# Product Emission Recall

## N212336951 Incorrect OBD System on VECI Label

**Release Date:** June 2021

**Revision:** 01

5834670

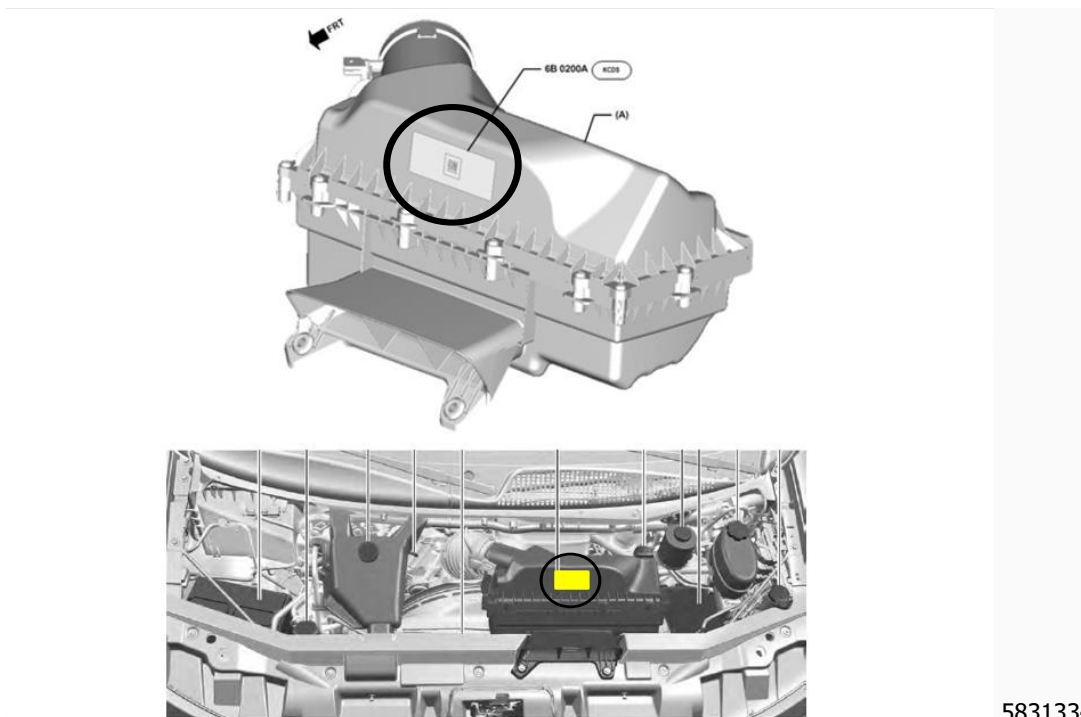
- Affix the new Vehicle Emission Control Information Label overlay onto VECI label in the spot specified (2). This is how the label should look when finished.
  - The old label will look as shown in (1), and will incorrectly say “CA: OBD: II,” with no line below that. The overlay, (3) is shown at the bottom.
- Close the hood.
